**CITY OF EVERETT
REQUEST FOR BIDS NO. 25-66
ADDENDUM NO. 3**

Project: #ENG-25-66

This **Addendum No. 3** is issued to amend the Request for Services for **Request for Bids for ENG-25-66 Woodland Playground Renovation**.

SHEET NUMBER:
L-301

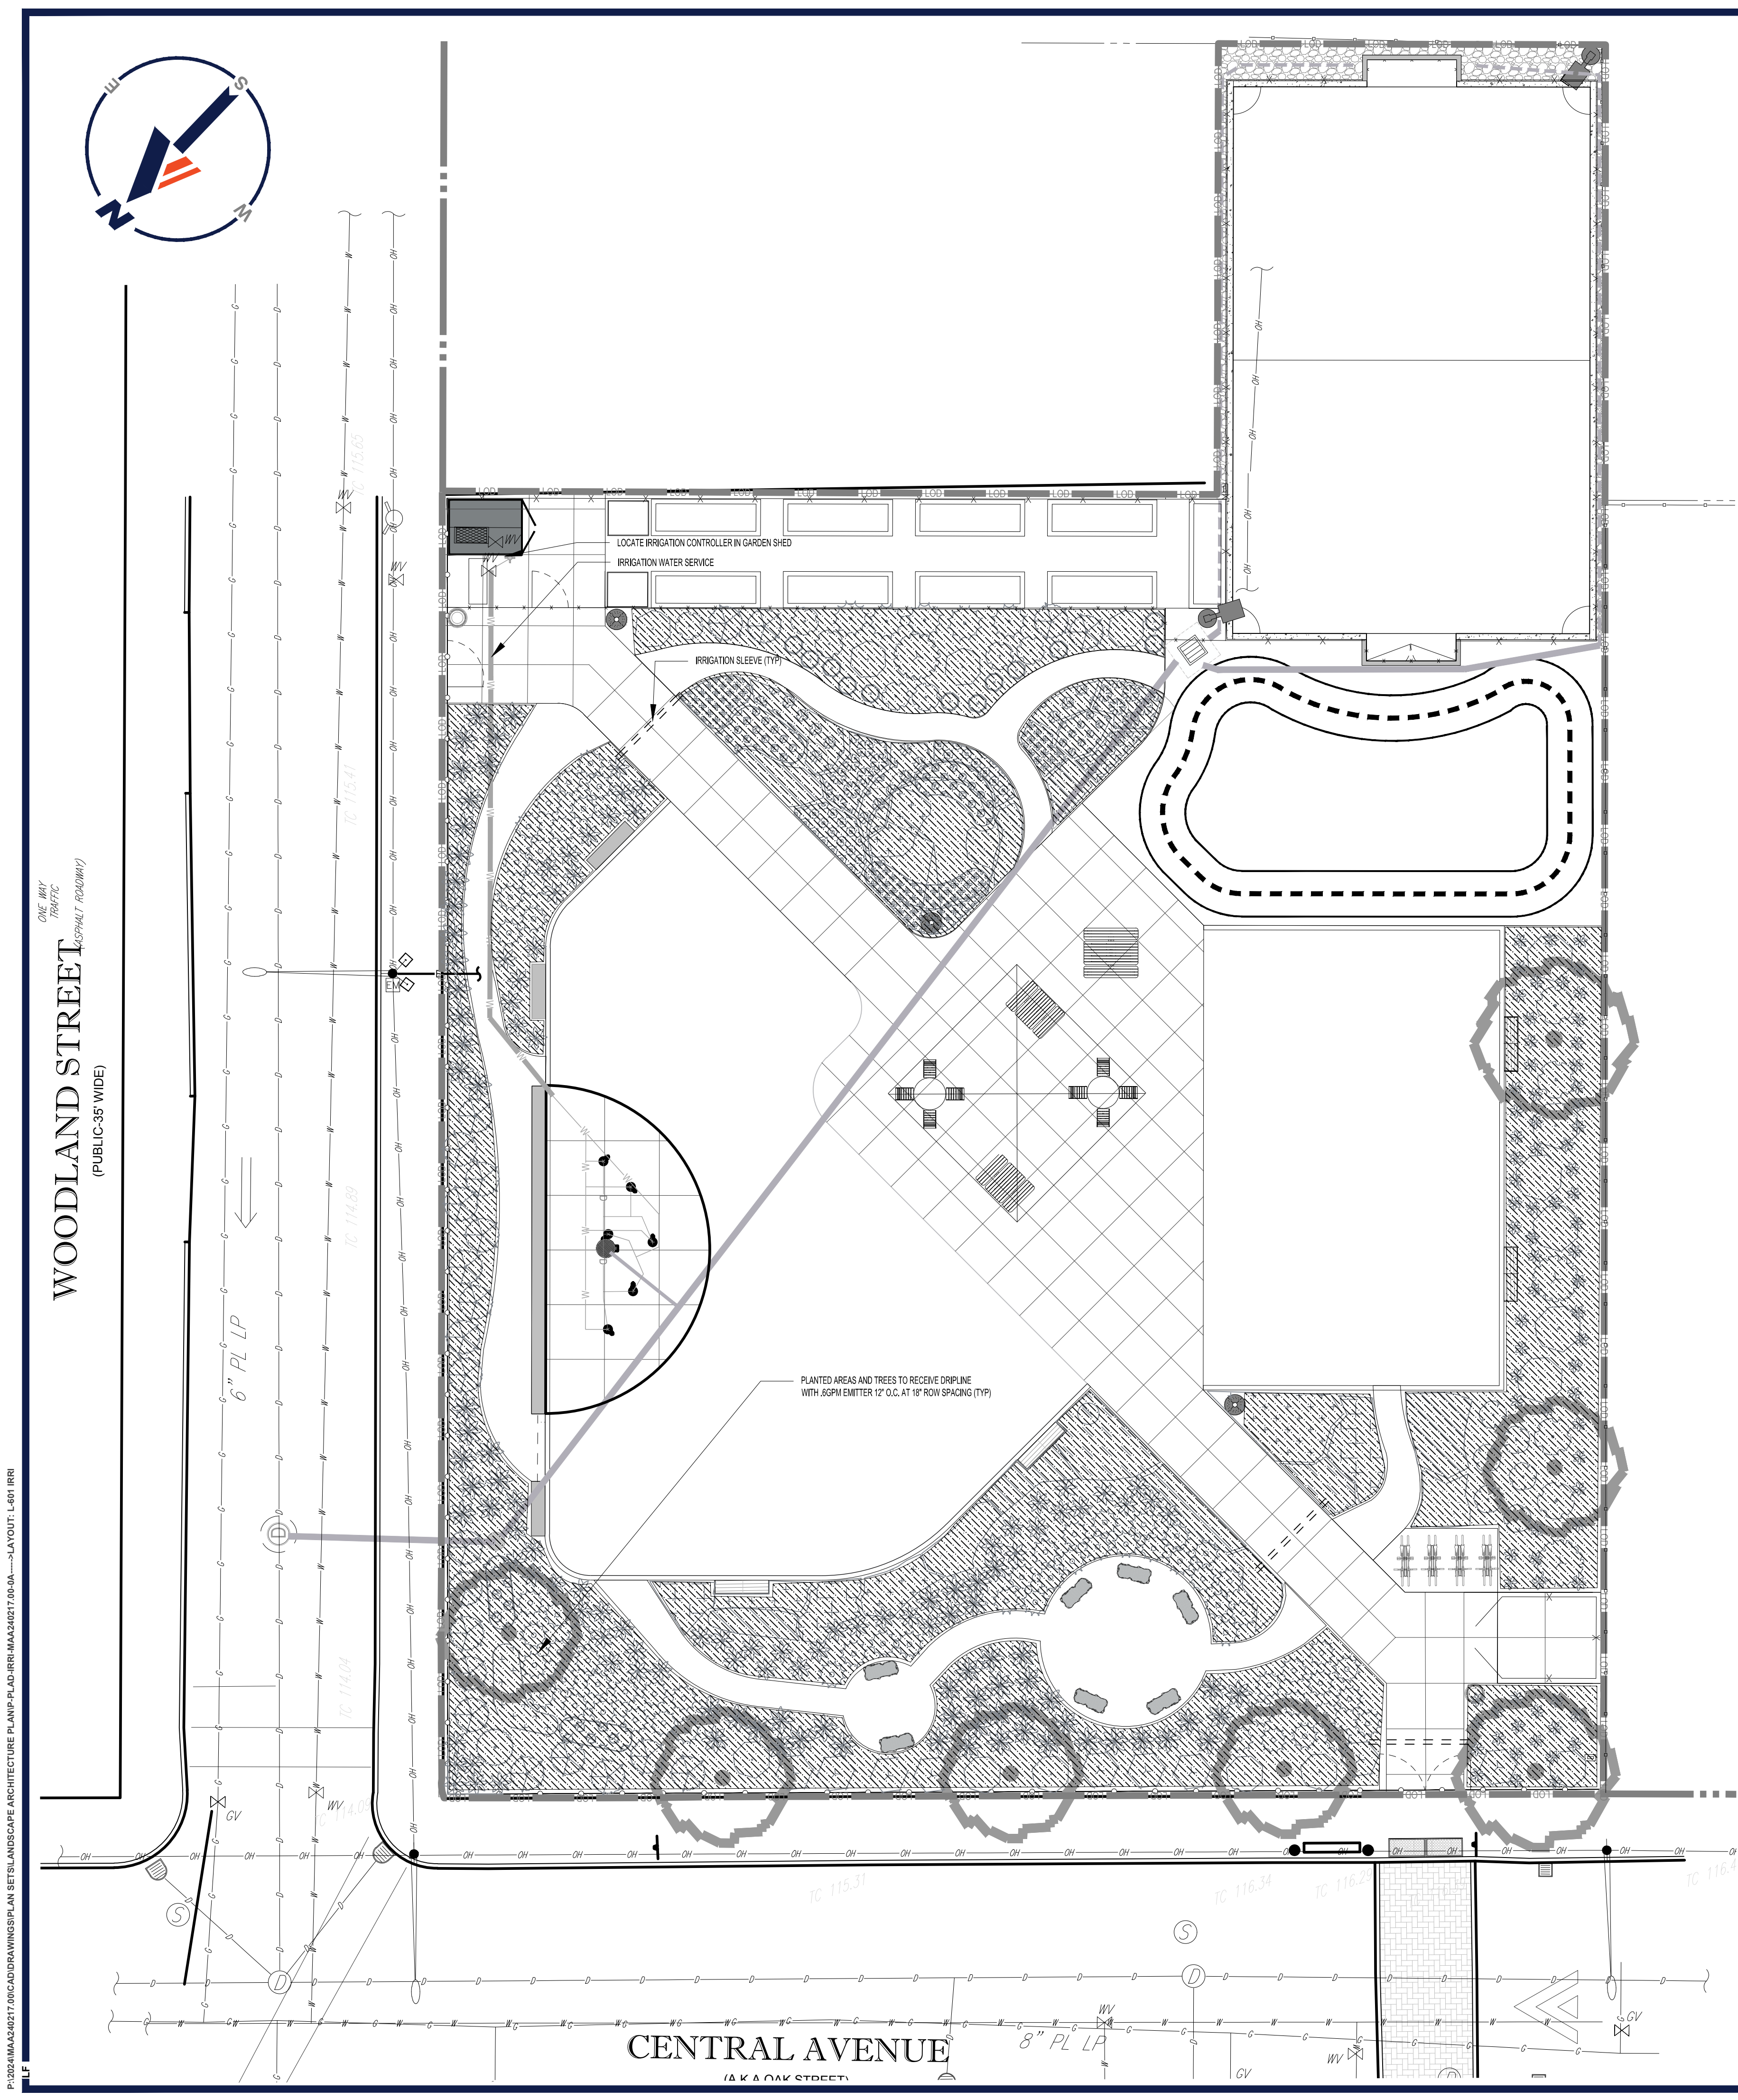
RESPONSE: NO privacy slats on the porto fence enclosure
13. There are two Type AL-1 light fixtures that are to be mounted 12' high on fence posts at the Futsal Court. The Futsal Court Wall detail shown on drawing L-902 shows the fence post as only 6'-4" high. Please advise how we are to achieve the 12' mounting height.

RESPONSE: Sheet L-301 indicates a separate 12' high light pole outside the Futsal Court. DO NOT install light or camera on Futsal Court fence post.

- a. **ART ELECTRICAL ENGINEER RESPONSE:** Provide light fixture with 12FT light pole. Mount camera on this pole. Mount camera as high as possible. Mount camera receptacle 6” below camera.
